**City of Harrisburg
Variance and Special Exception Application**

Primary Property Address	Zoning District
100 N 13th Street, Harrisburg, PA 17103	Residential Mid-Density

PLANNING BUREAU CASE REPORT

**RESOLUTION
OF
HARRISBURG PLANNING COMMISSION**

NEW SITE PLAN
 A001 SCALE: 3/32" = 1'-0"

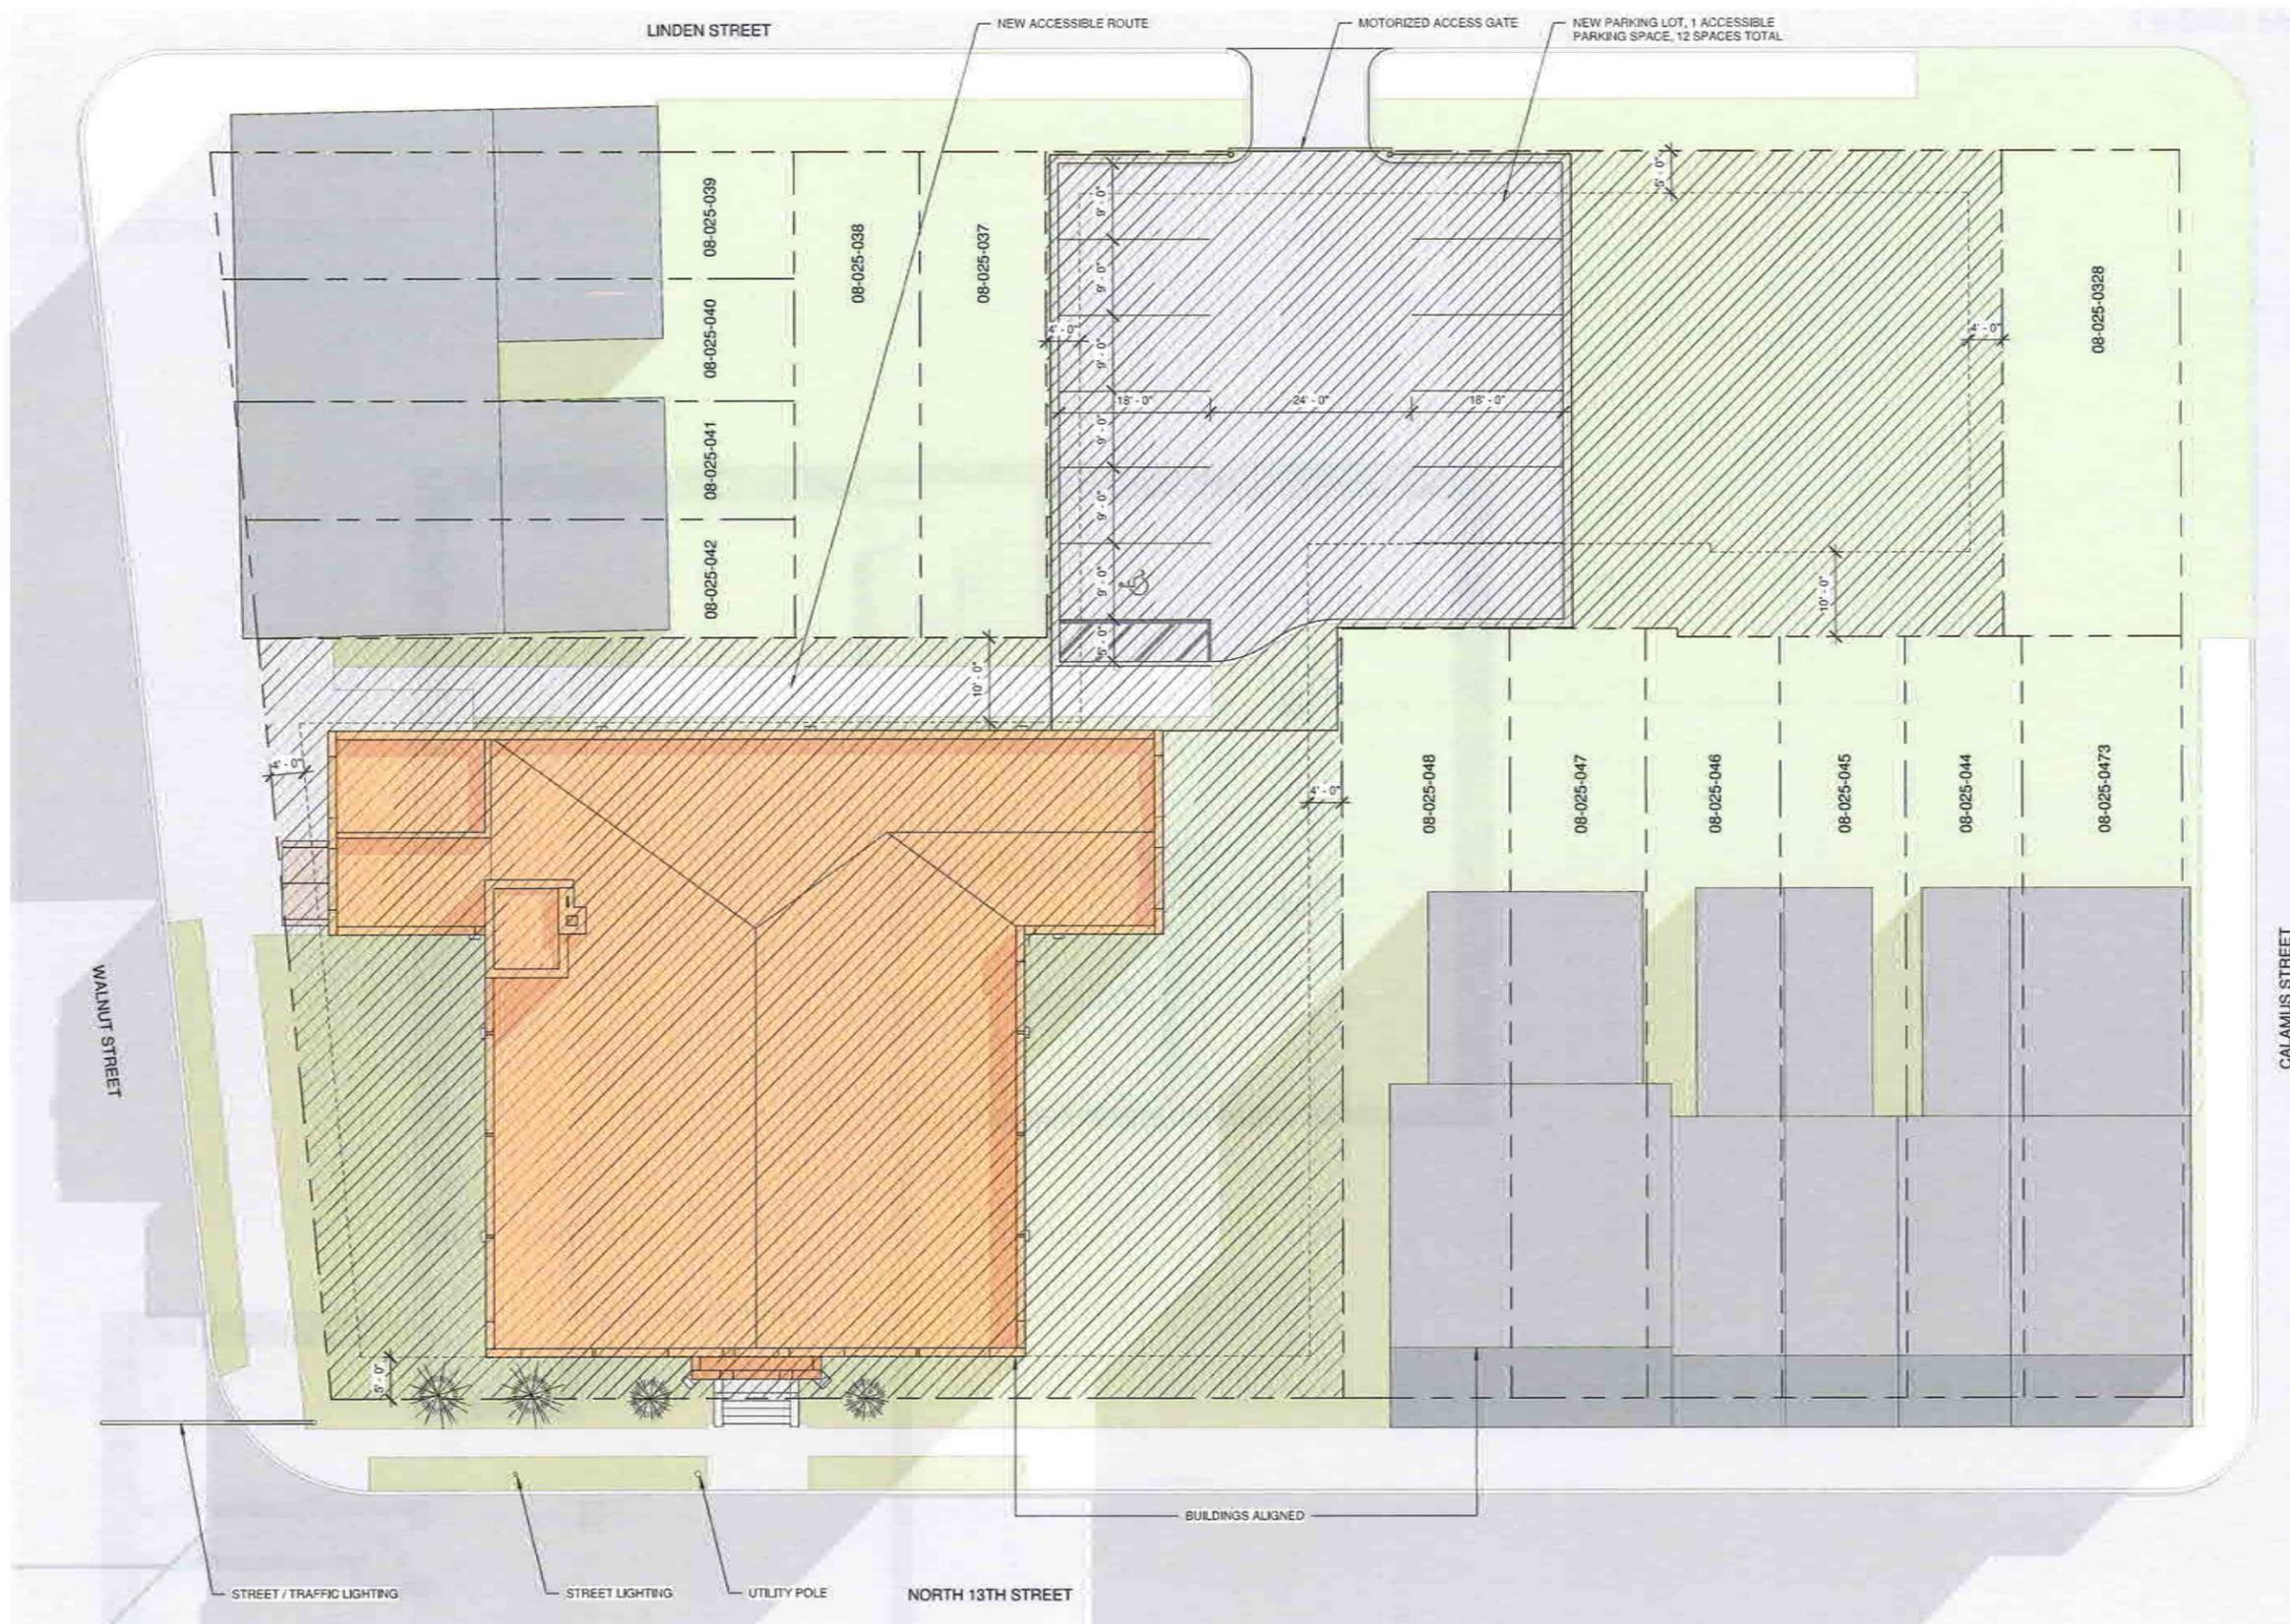
The Planning Bureau notes that Section 7-327.6 of the Zoning Code requires one (1) off-street parking space per unit and one (1) space for each five (5) units for guest parking; by this criterion, the Applicant would be required to have thirteen (13) off-street parking spaces. The Applicant is proposed to construct a twelve (12)-unit accessory parking lot, accessed from Linden Street, to accommodate the requirements. However, the Bureau notes that this design necessitates encroachment into required yard setbacks and does not leave room for the requisite vegetative screening that improves the appearance of the property and reduces glare from headlights into neighboring properties. As such, the Bureau is recommending that the Applicant remove two proposed spaces, which allows the installation of the required screening and obviates the three Variances the project otherwise requires.

The Planning Bureau notes that the Applicant has referenced proposed fencing to enclose the off-street parking lot on Linden Street; however, the Applicant has not provided specific information related to the height or material of the proposed fencing, so the Bureau is unsure of whether the fencing will be in conformance with the Zoning Code. Additionally, the Bureau notes that the landscaping requirements in Section 7-307.11(c) of the Zoning Code indicate that “any fencing shall be placed on the inside of any landscaped or plant screen area;” thus, the Applicant will still be required to provide vegetative screening around the perimeter of the fence. The Applicant has filed a Variance to request relief from the parking lot screening requirements, but this aspect of the proposal is not being supported by the Bureau. Additionally, the Bureau notes that the accessory parking lot will be slightly more than 3,000 square feet, and will thus be required to plant a tree on-site or in the surrounding public rights-of-way.

The Planning Bureau notes that the Applicant has only outlined the Variances they are requesting and not actually identifying any conditions that necessitate or justify these requests. As outlined elsewhere in this case report, the Bureau notes that the Applicant could obviate all three Variance requests if they removed two off-street parking spaces (resulting in ten of the required thirteen off-street parking spaces), and used the resulting space to relocate the parking lot footprint out of the setback areas and to install the requisite plant screening around the lot.

The Planning Bureau notes that the current design envisions the parking lot encroaching into most of the front yard setback (behind the buildings fronting North 13th Street) and the rear yard setback (along Linden Street); this design provides nearly the required off-street parking. In this sense, the Variance requests related to the Development Standards in Section 7-307.3 represent the minimum needed to afford relief. This design also means that it is difficult to provide space for the required landscape screening around the perimeter of the parking area, whether the project includes a fence or not. However, even if approval of the setback encroachment is

approved, there is still space to install plant screening to the north and south of the parking lot, and the Bureau believes that should be required at a minimum.

Given the above, the Bureau feels that the Applicant should remove two spaces from the proposed off-street parking area to obviate the Variance requests and include a plant screening around the perimeter of the lot.

4. The Planning Bureau recommends that the proposed parking area be reduced by two spaces to create room for the required vegetative screening, and potentially handle stormwater management on-site; while the Applicant has indicated that a fence will screen the parking lot, the Zoning Code requires vegetative screening be installed on the outside of the fence. The Bureau also notes that if the required tree is not planted on-site, it can be planted in a tree pit in the surrounding rights-of-way.
